**ADDENDUM NUMBER:** ONE (01)  
**ADDENDUM DATE:** December 05, 2016  
**ISSUED BY:** SEPW Architecture Inc.  
102 – 3718 Kinnear Place, SK. S7P 0A6  
PH. (306) 652-6457  
**PROJECT:** New Modular Police Building  
Ahtahkakoop, Saskatchewan

This Addendum forms part of the Contract Documents and amends the original Drawings and Specifications dated 2016-08-12, previous Addenda if applicable and as noted below. This Addendum consists of 33 pages.

**E-1-5 REF. DRAWING E2.1 – MAIN FLOOR LIGHTING PLAN**

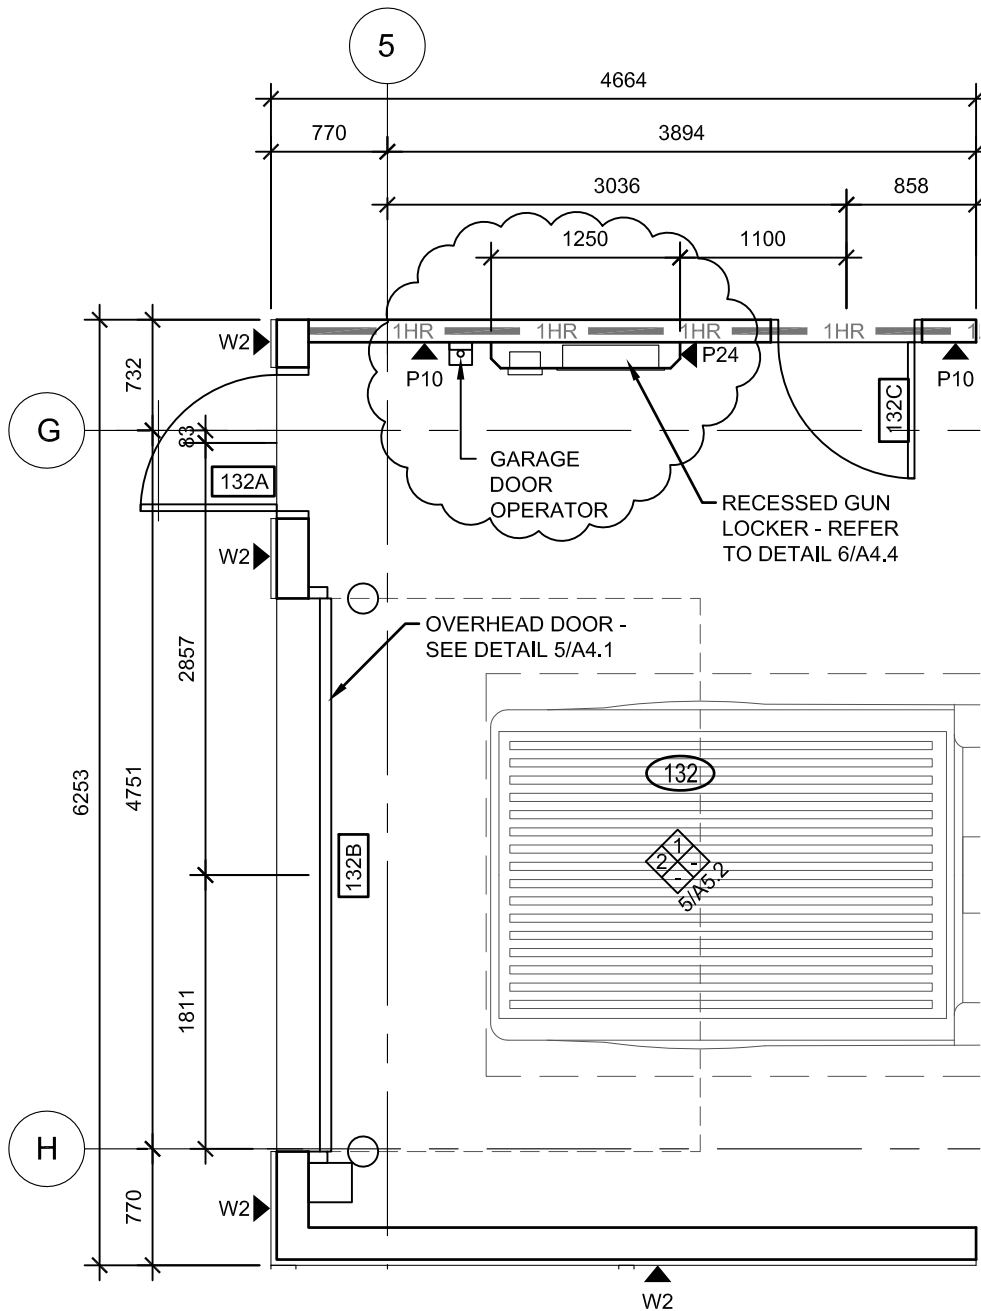
1. Revise the light switch location for Room 137 from inside the room to Corridor 130 adjacent to the latch side of Door 137.

**AR-01**

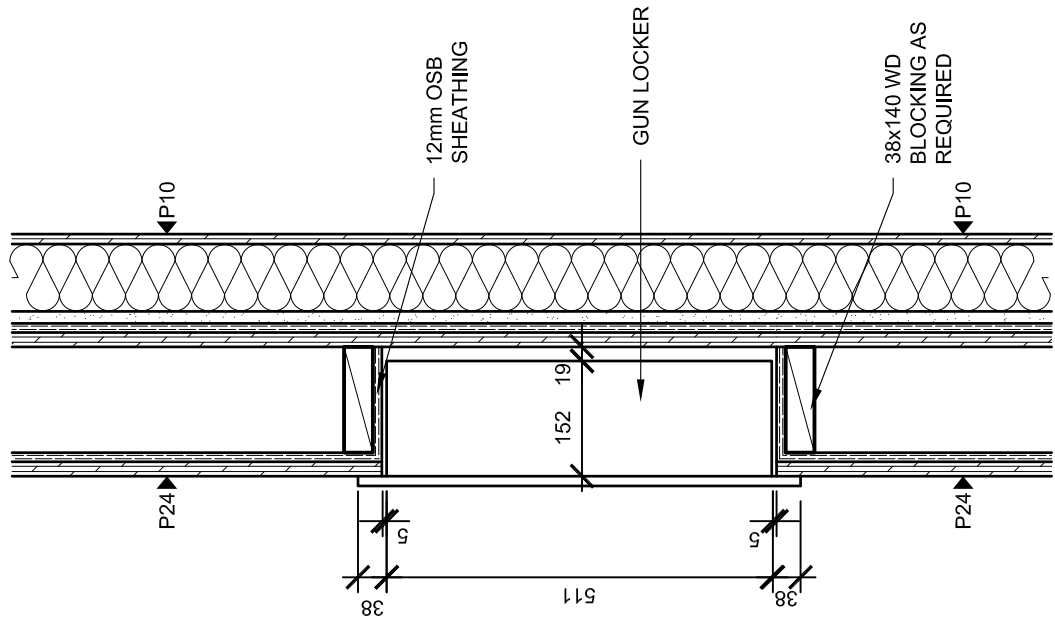
2. **Revise:** buildout on plan 3/A2.11 as shown on the attached sketch AR-01. Revise corresponding detail 6/A4.4 as shown on AR-02.

1 ROOF ANCHOR DETIAL – PLAN 1:20

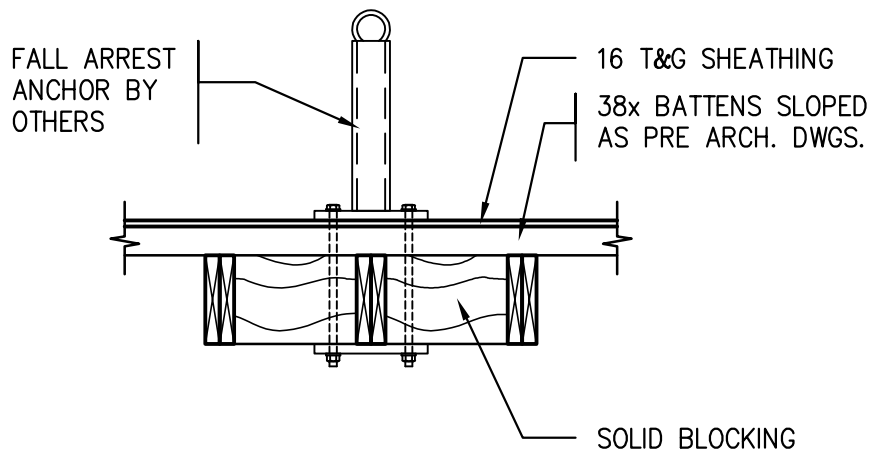
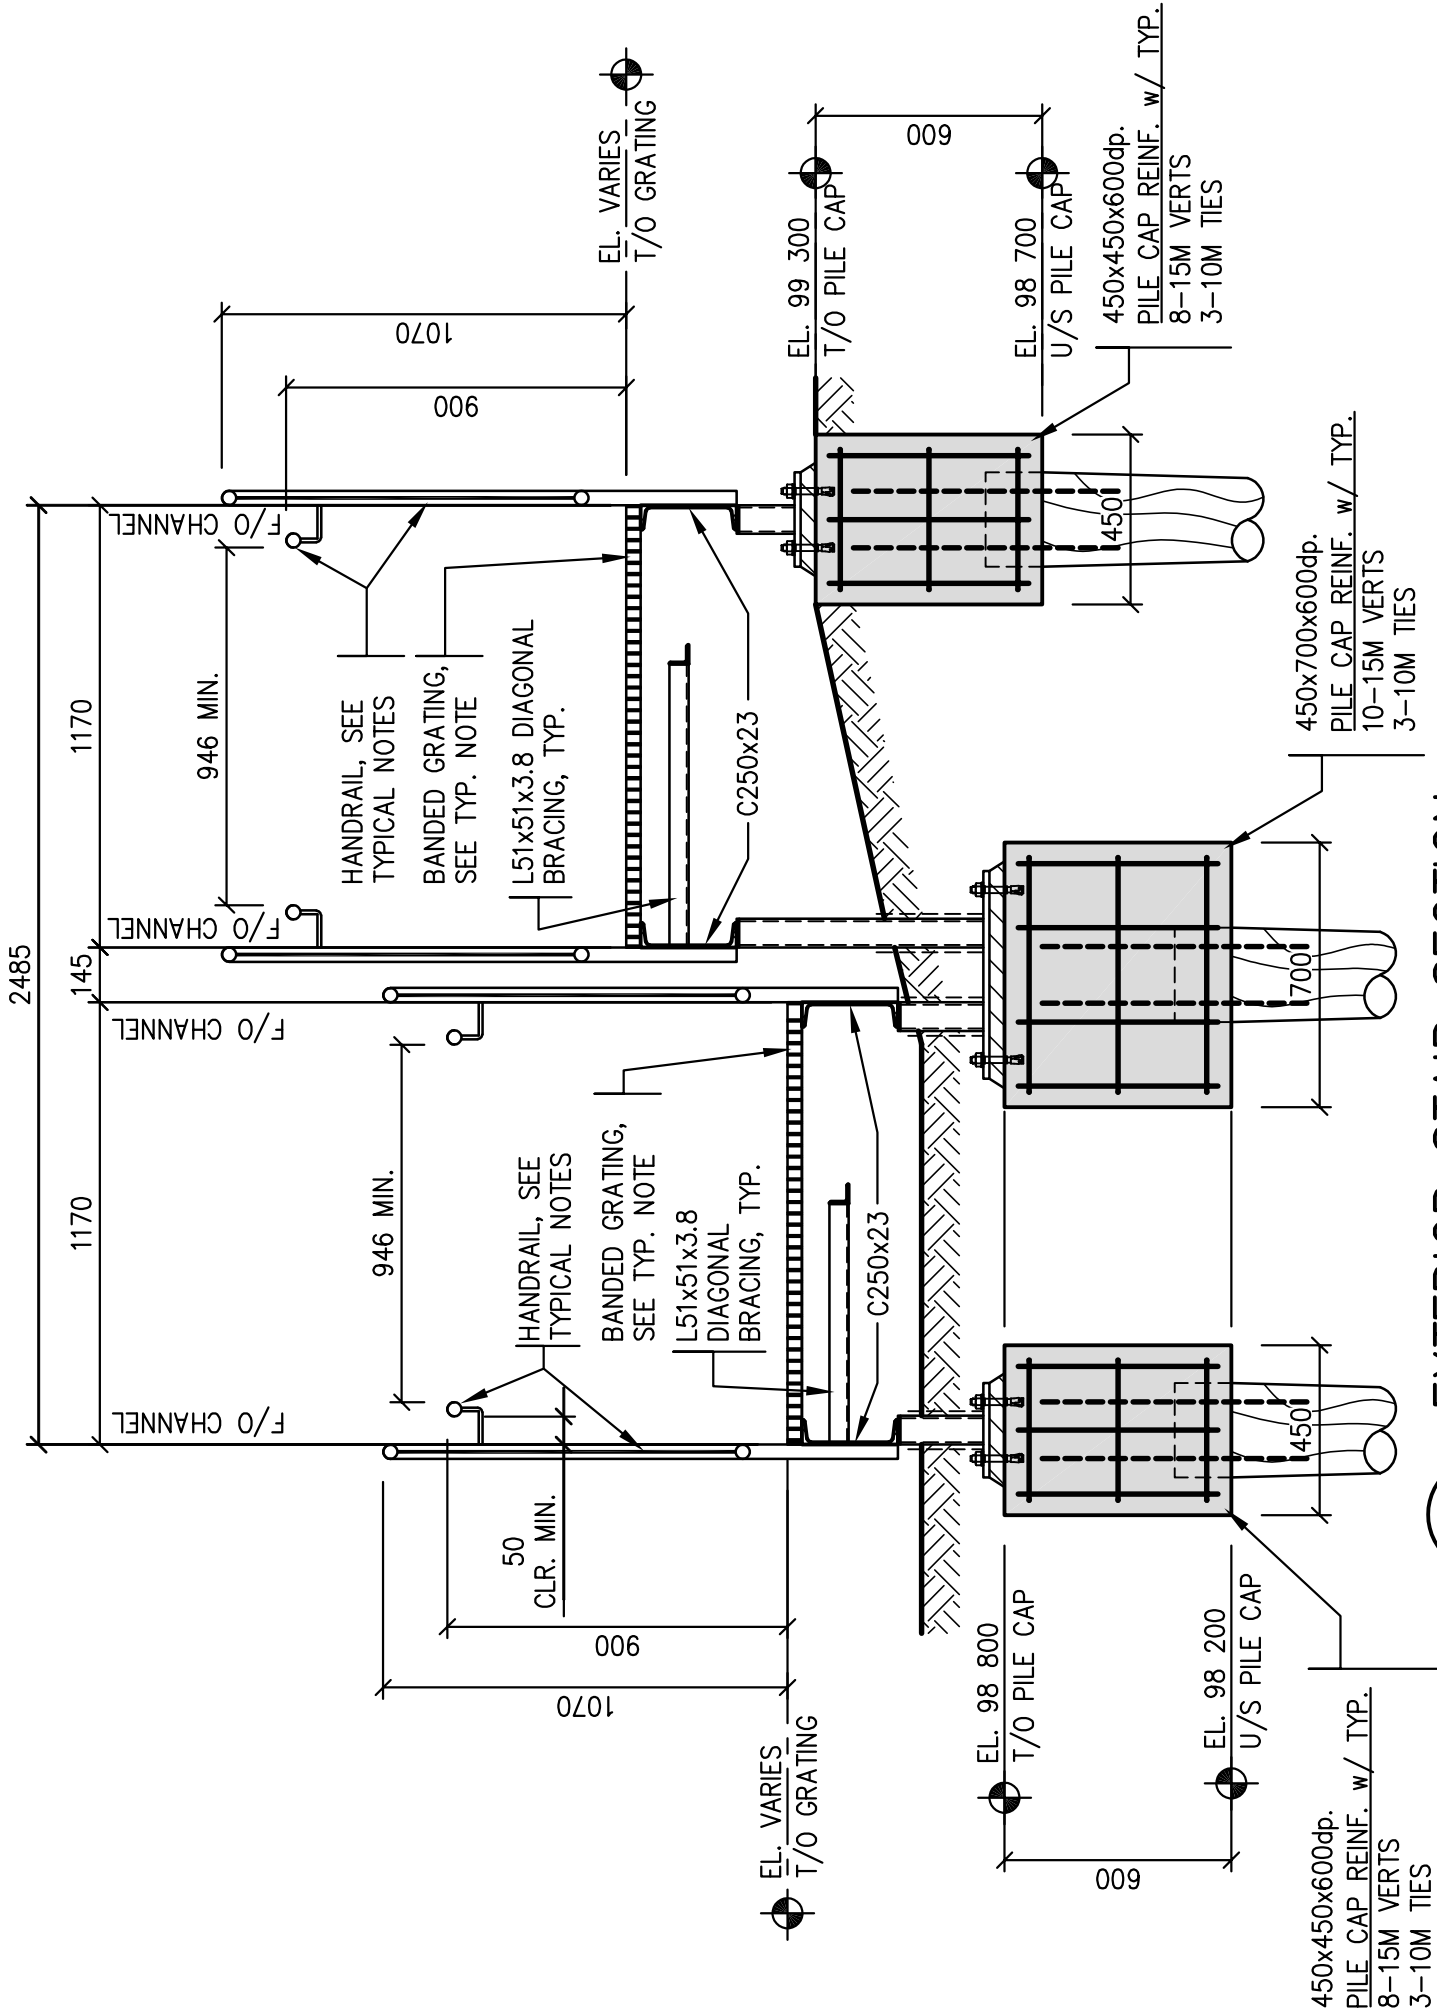
1. Typical fall arrest anchor framing to be at all locations of fall arrest anchors. See attached sketch SK1 for detail.

# EXTERIOR STAIR SECTION

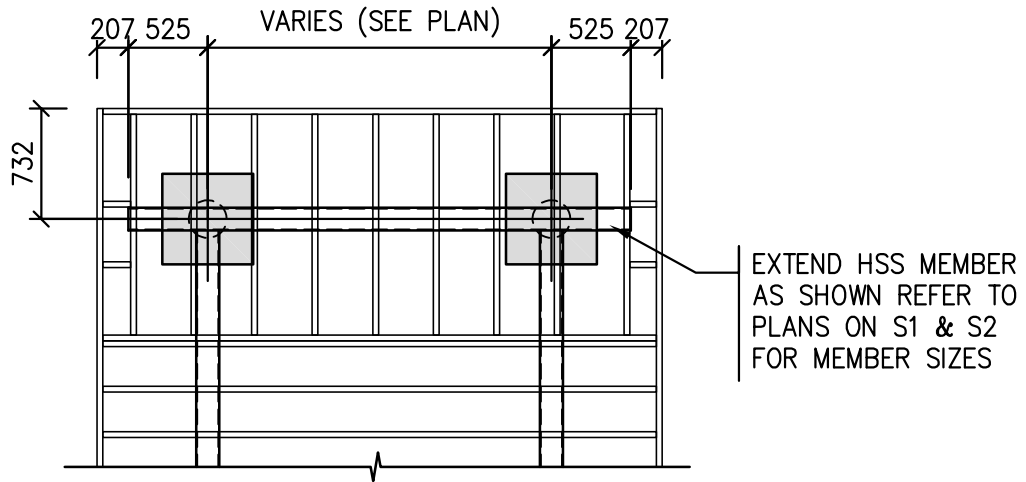
1. Refer to 2/S13 revise landing dimension from 3132 to 2708.
2. Refer to 3/S13 and replace with attached sketch SK2.

## HSS FRAME DETAIL UNITS 1-16

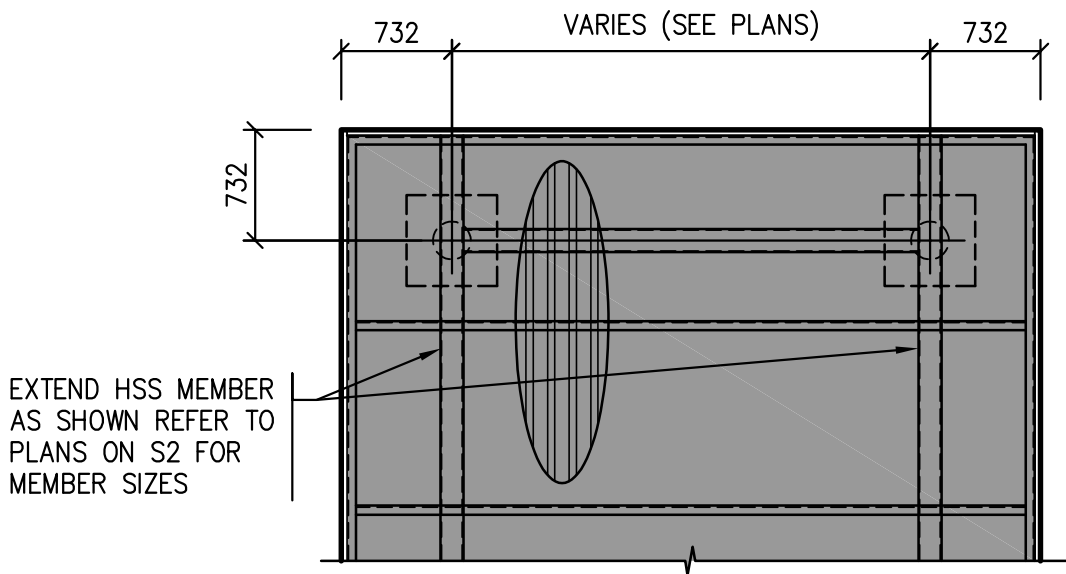
11. **Q:** How wide or far away from the building edge does the rigid insulation extend?  
**A:** Refer to detail 1/A4.1.
12. **Q:** Detail 3/ S6 shows typical HSS extension 525mm from center of pile to edge, detail 1, 2/S6 do not show this extension, but all unit plan view on S2 show all the HSS along the unit width way has extension, Are all the HSS with extension only at unit corner piles along width way? Or are the HSS with extensions at all HSS tubings along width way and length way?

**A:** HSS to cantilever widthwise for all units except 17 and 18. Units 17 and 18 to cantilever lengthwise. Refer to sketch SK3 for clarification on the direction of the cantilever for the HSS members supporting the units floor structure.
